QUESTIONS AND RESPONSES  
FOR THE OCONEE NUCLEAR STATION  
INDEPENDENT SPENT FUEL STORAGE INSTALLATION  
ENVIRONMENTAL REPORT

Figure 2.1-3

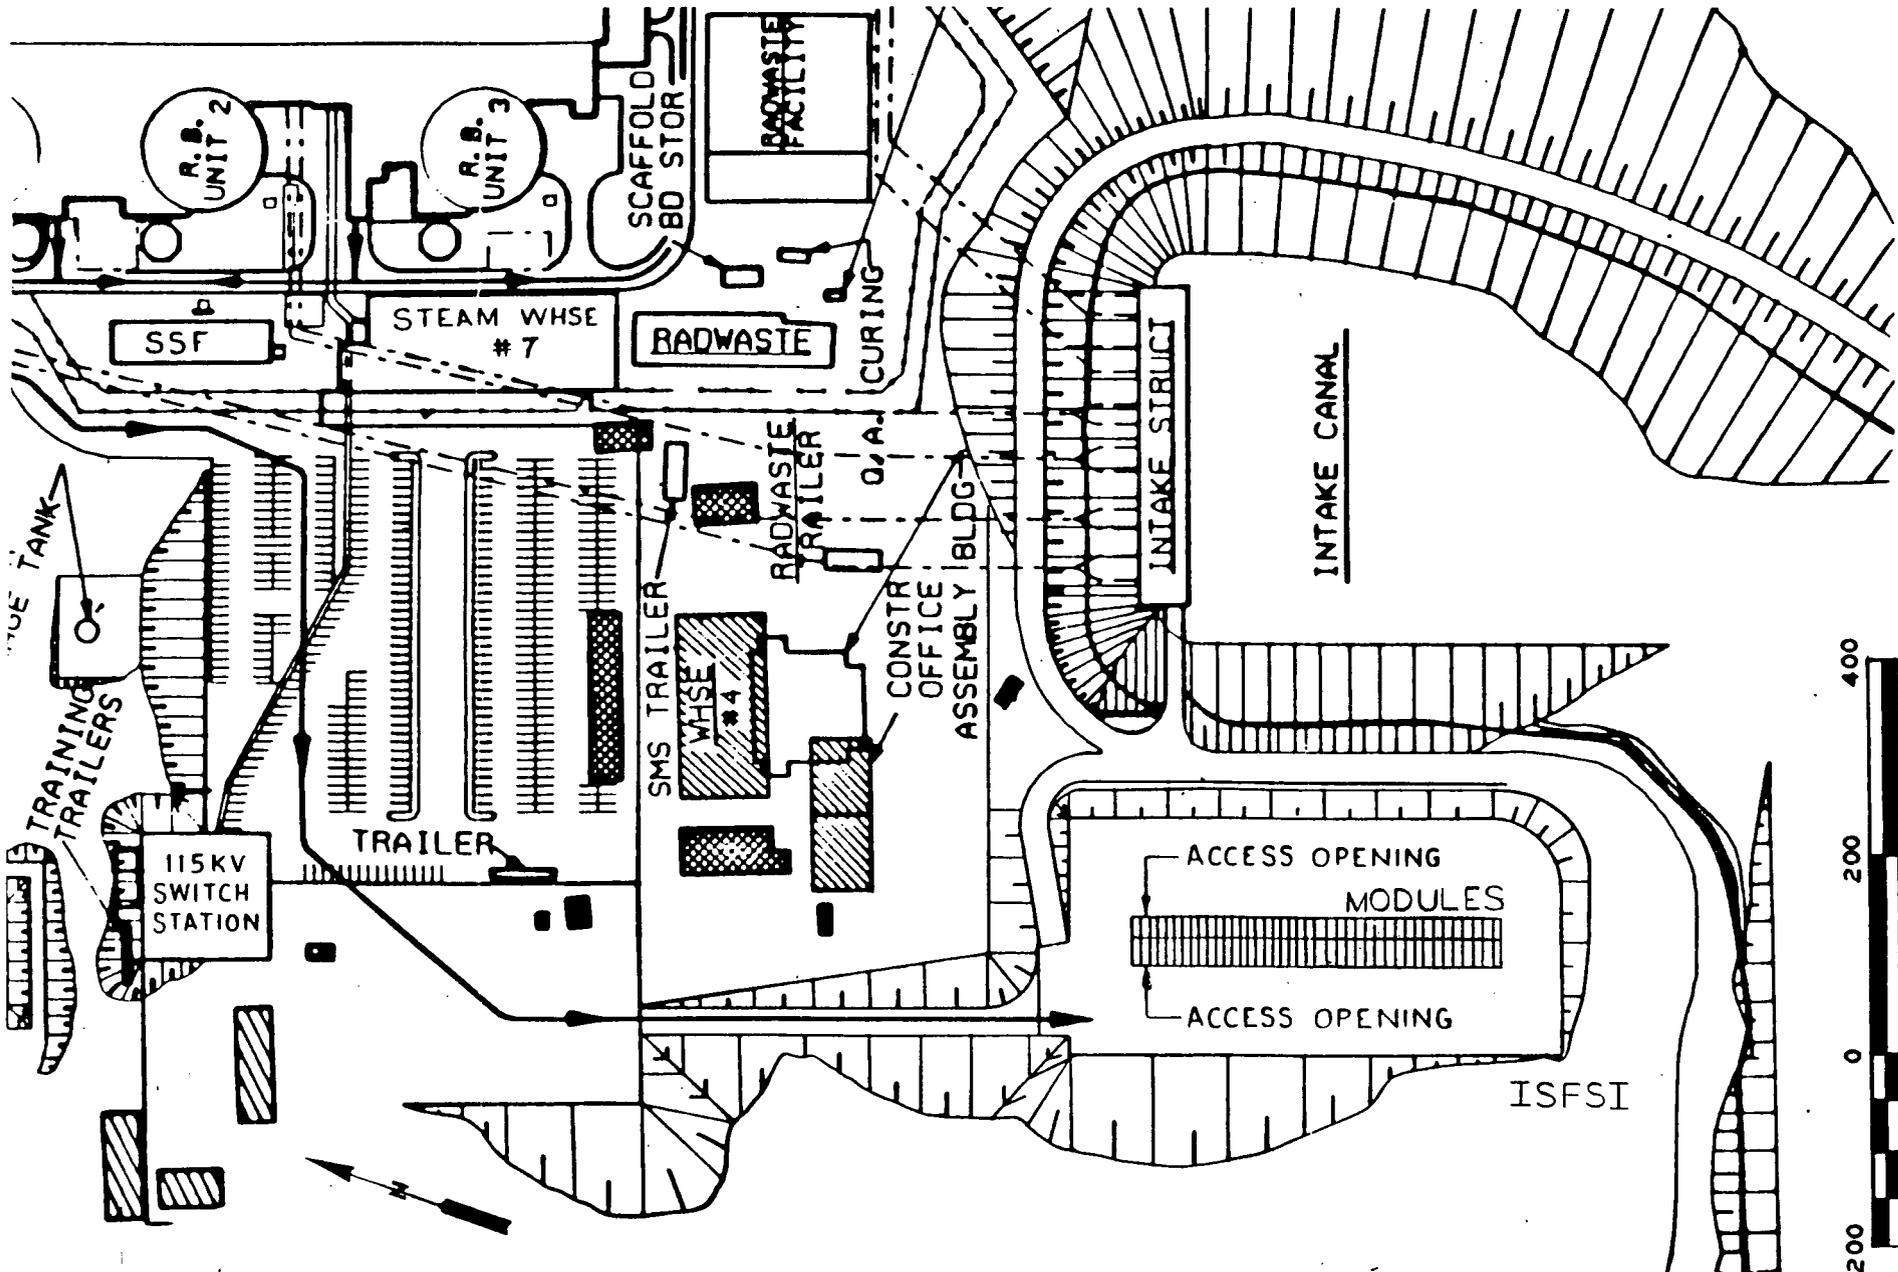
Question 5: The absence of any scale, particularly for ER Figure 2.1-3, detracts from its use. If the ISFSI is located, as stated, 100 feet west of the intake structure, then the dimensions of the ISFSI are roughly 130 by 230-feet and it therefore occupies a little over one-half acre. Why then, will 3-4 acres be required for construction of the ISFSI? Will the 88 modules, in fact, fit into the roughly estimated 230-foot length of the ISFSI? Are the short and long routes (SAR Fig. 4.1-1) from the cask handling area to the ISFSI about 1,200 and 2,200 feet in length, respectively? Why then, does it take an hour (SAR Table 7.4-1) to traverse even the longer route, which is less than one-half mile?

Response: The eastern edge of the ISFSI site is located approximately 210 feet west of the intake structure. The east-to-west dimension of the ISFSI site is approximately 253 feet and it measures 510 feet north-to-south (reference ER Figure 2.5-1). The approximately 3-acre ISFSI site includes a 20 feet wide controlled access area for security purposes around its perimeter. Concrete HSMS are spaced approximately 8'8" on centers and have a front-to-back depth of 20 feet. The 88 module Oconee ISFSI will be constructed in two back-to-back rows with 44 HSMS in each row. Therefore, the total depth of the 88 HSM array will be 40 feet, and its total length about 400 feet. The ISFSI yard is sized to accommodate the docking maneuvers of the tractor pulling the transfer cask mounted on its trailer. The short and long transfer routes from the Oconee cask handling area to the ISFSI are about 2,500 feet and 4,800 feet in length, respectively (reference SAR Figure 4.1-1). The primary purpose of SAR Table 7.4-1 is to permit the calculation of total dose received by a canister transfer. NUTECH's Topical Report (Reference 3.1) states that the transfer operation may take as long as one day. Durations required to traverse the transfer routes are yet to be determined and will vary according to conditions prevalent at the time of transfer.

Revised versions of the following figures are included:
